Test lead set, 'Voltage Test Lead, 3-phase + N', included with Fluke 173x, 174x Power Quality Loggers and 3540FC Power Monitor

CRITICAL SAFETY ALERT – PLEASE READ!

June 2018

173X Series and 3540FC Incorrect 3-Phase Test Lead Connection

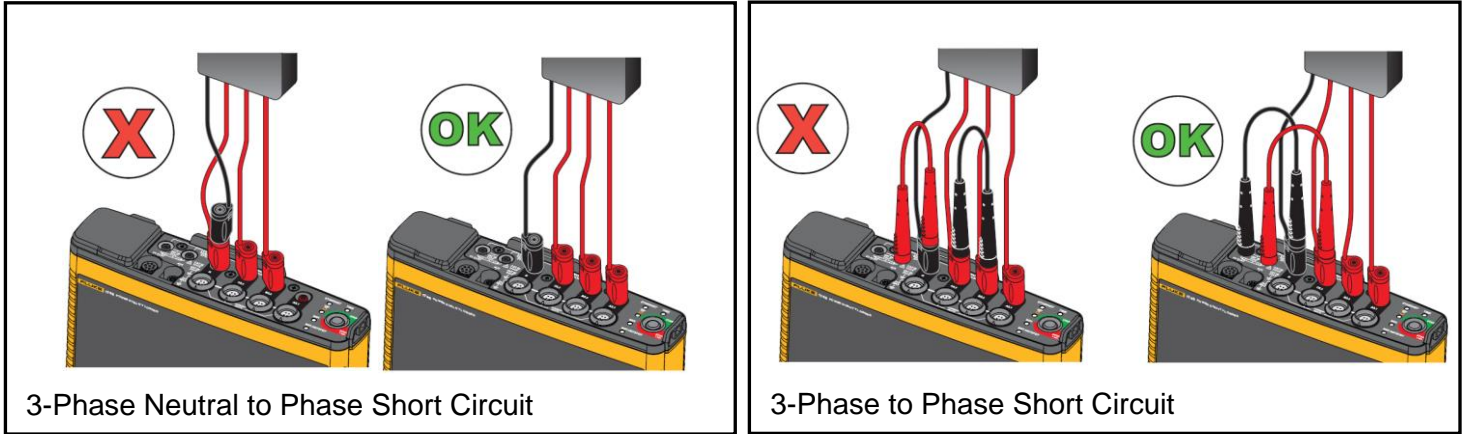
While these test leads are compliant with applicable safety standards, it is possible for a user to miswire the voltage connections on the test lead set when making connections to a Logger. See the diagrams below for examples of miswiring errors.

While the possible wiring errors shown below may seem obvious to trained personnel, if this miswiring were to occur, a phase-to-phase or phase-to-neutral short circuit could result, potentially **causing an arc explosion and posing the risk of serious personal injury or death.**

Examples of possible miswired voltage connections resulting in a short circuit (VOLTAGE CONNECTION ERRORS ARE INDICATED BELOW WITH A RED 'X'):

Fluke urges you to discontinue use of the 'Voltage Test Lead, 3-phase + N' cable set and contact Fluke for a free replacement test lead kit. This replacement test lead kit incorporates straight banana connectors rather than stackable connectors.

Replacement test lead set installed.

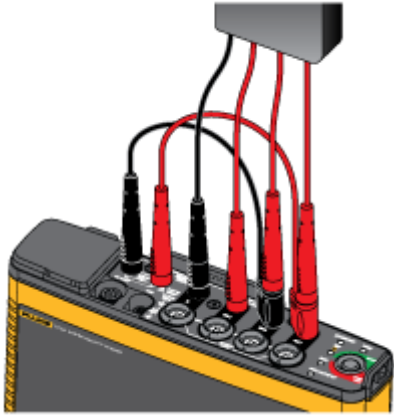
To facilitate powering the Logger from the measurement terminals, the replacement test lead kit additionally includes short jumper accessories with both a stackable connector and a straight banana connector. **The configuration of this replacement test lead kit eliminates the possibility of miswiring the terminals.** See below.
